**Infrastructure and Transportation**  
Highway Planning and Design Branch  
Environmental Services Section  
1420-215 Garry Street, Winnipeg, MB R3C 3P3  
T 204-619-4359 F 204-945-0593  
www.manitoba.ca

April 10, 2015

**SUBJECT: Notice of Alteration - Environment Act Licence No. 3131  
St. Adolphe Ring Dike Expansion**

Attachment 2  
Plan and Profile View of the Outlet Configuration

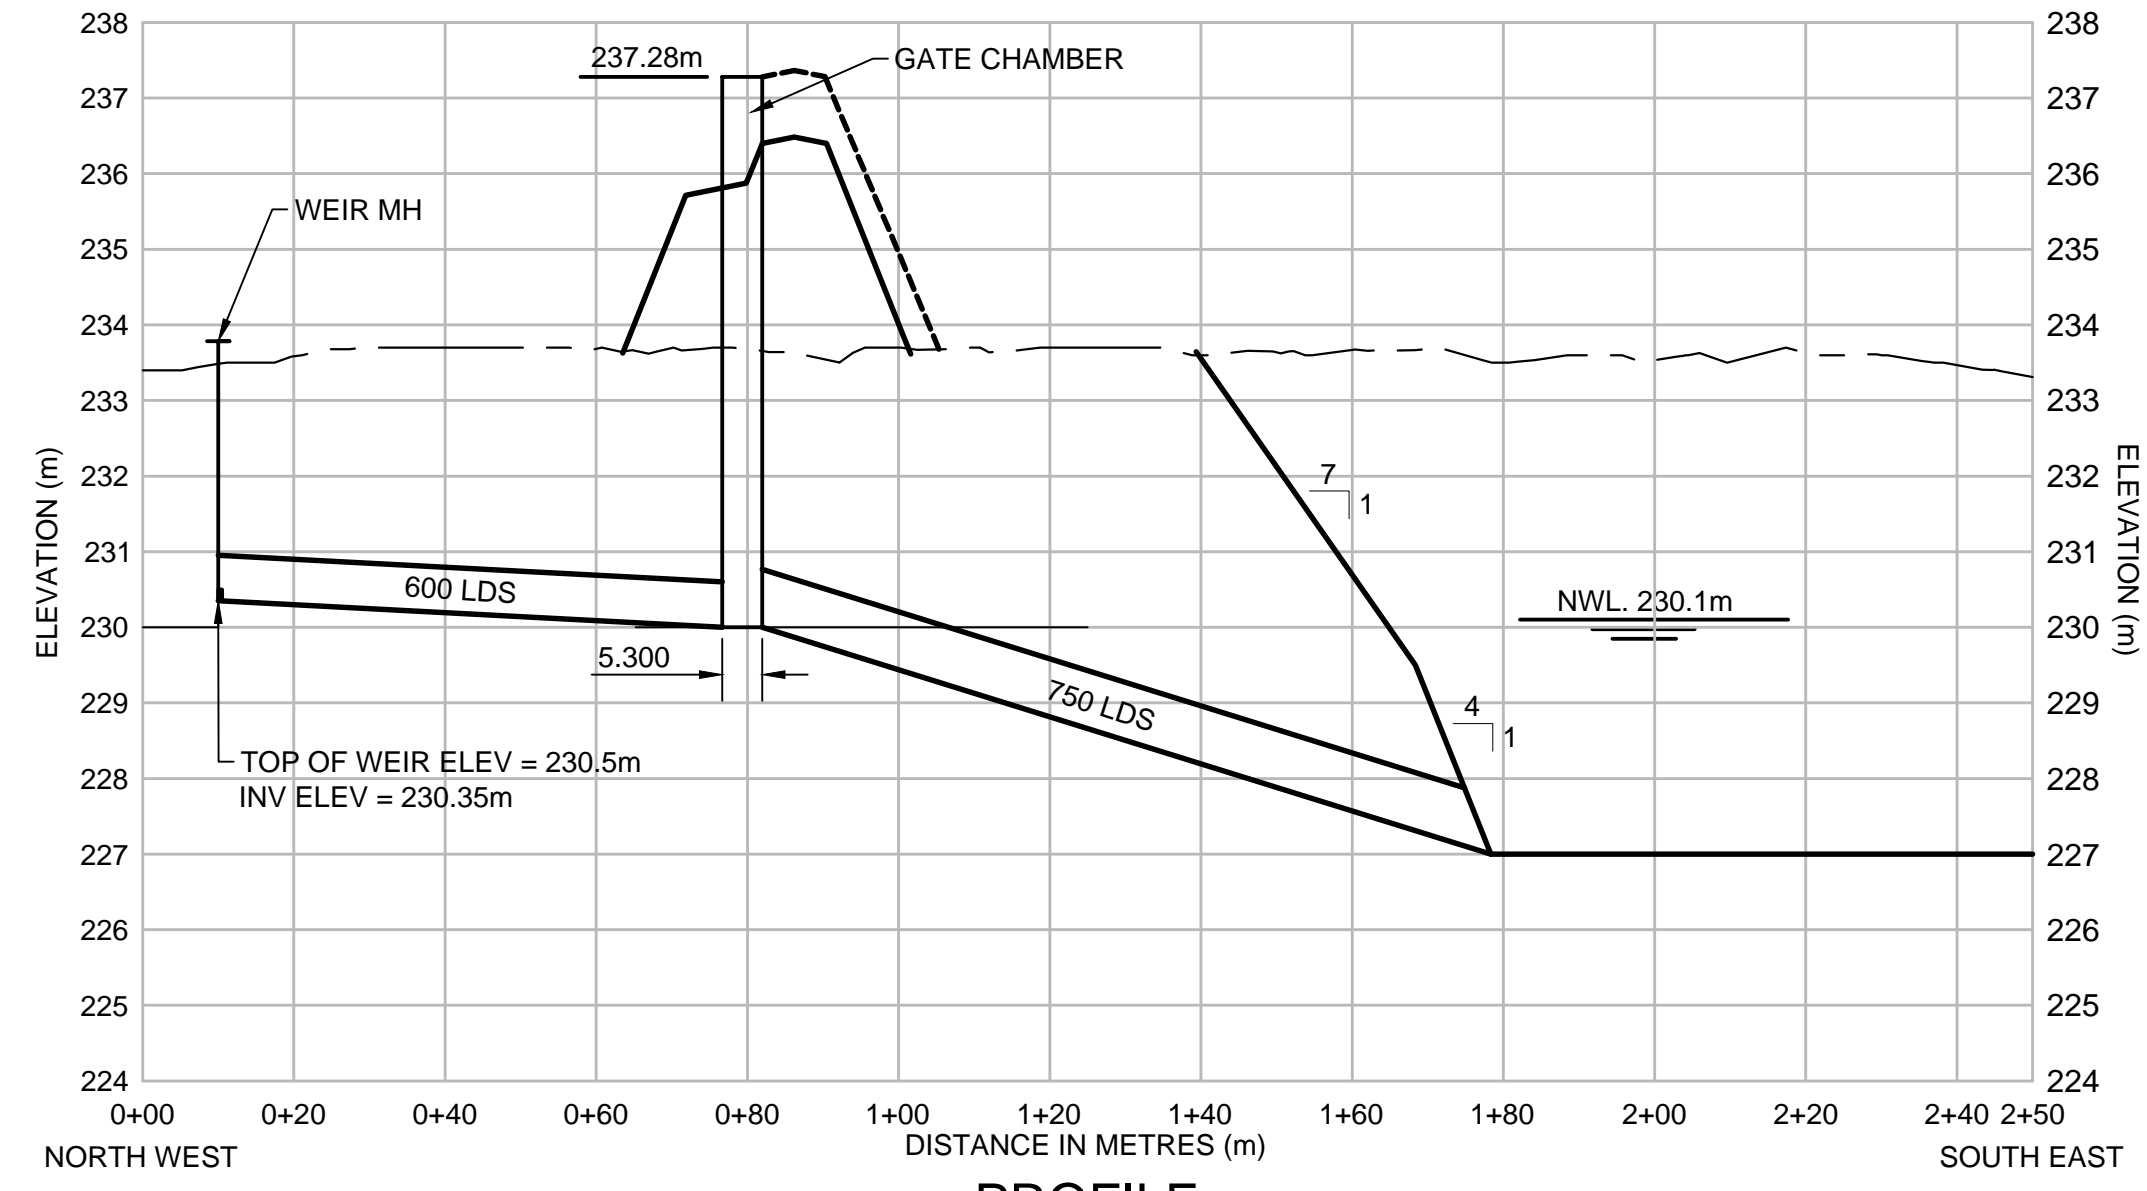
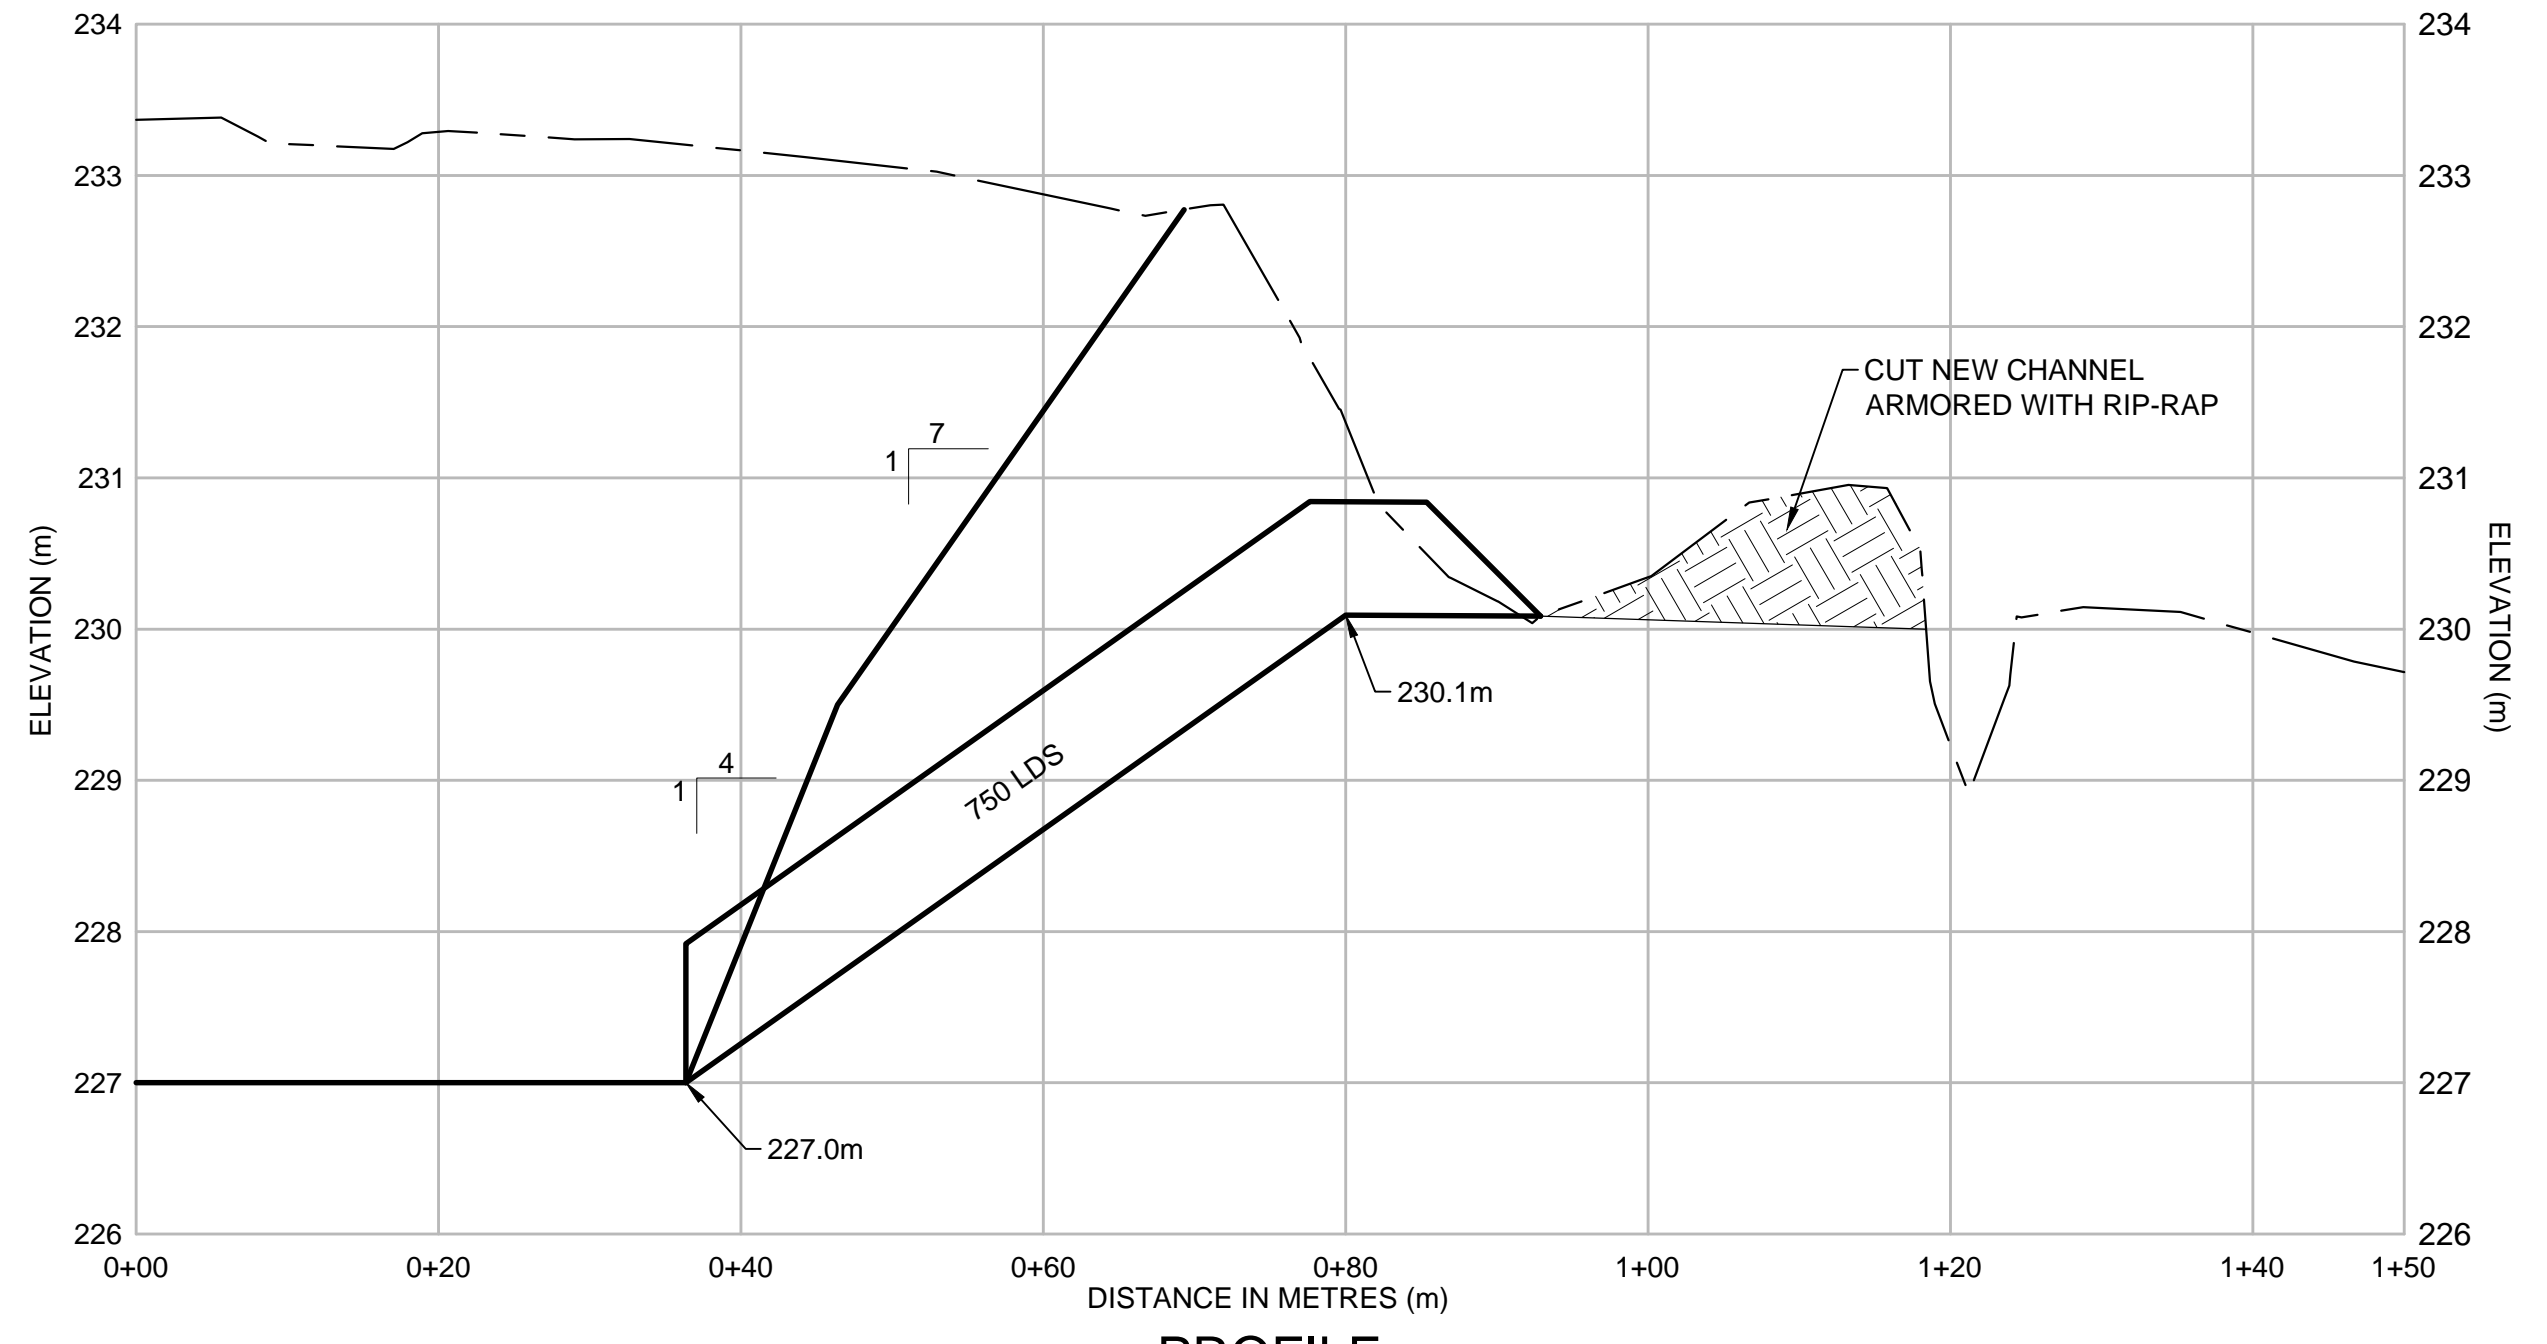
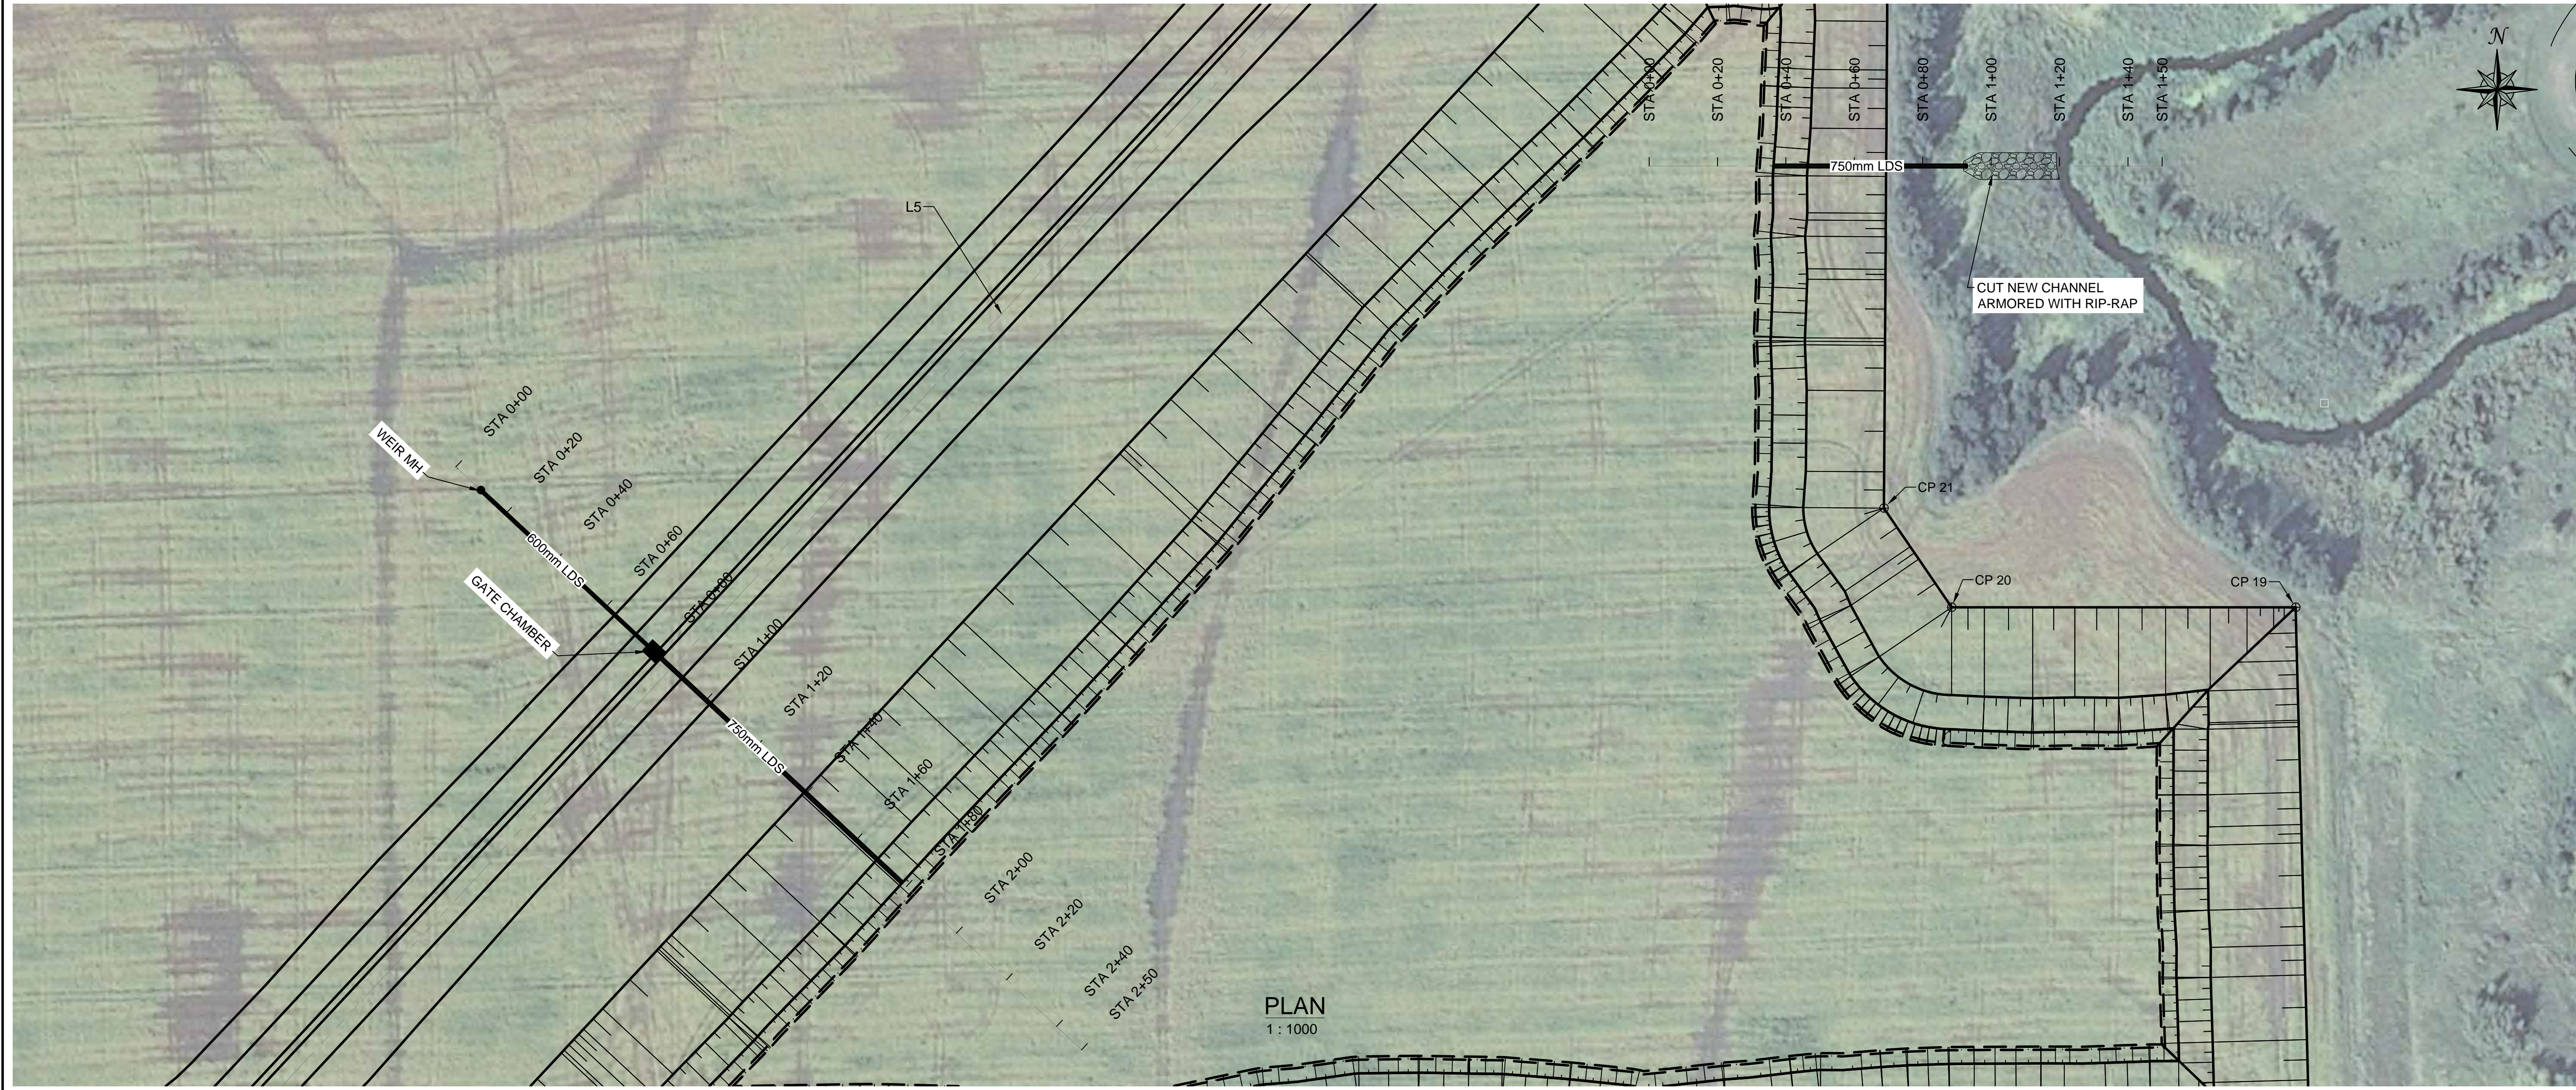
Borrow area A-3 will be excavated to a depth of 6 m and will function as a wet retention pond for urban storm water run-off originating from within the expanded ring dike. Water will enter the retention pond in a controlled manner through a flood control structure built into the new dike alignment. Attachment 2 shows the draft outlet configuration from the development area to borrow area A-3 (borrow pond) to the St. Adolphe Coulee.

The weir manhole controls the Sewer Retention Basin (SRB) system in the upstream development area, and provides attenuation to allow for solids to settle before leaving the development's drainage system. The weir manhole and the Flood Protection Structure (FPS) are connected via a 600 mm Land Drainage Sewer (LDS). The FPS will be located on the dry side and adjacent to the proposed Ring Dike, and will be set to an elevation to accommodate the 1:200 year level. The FPS is connected to the borrow pond via a 750 mm LDS, which will discharge to the bottom of the borrow pond where rip rap will be placed to negate erosion.

Similar to the outlet of the 750 mm LDS, the inlet of the outfall from the borrow pond to the St. Adolphe Coulee will consist of rip rap to negate erosion at the bottom of the pond area. The 750 mm outfall pipe will be sloped upward to discharge to the St Adolphe Coulee at an elevation of 230.1 m, which will be the Normal Water Level of the borrow pond. It is not anticipated that sediment laden runoff will enter the borrow pond, as settlement is provided in the developments LDS system (via catch basin sump pits and SRBs) and very little local runoff is anticipated to the pond.
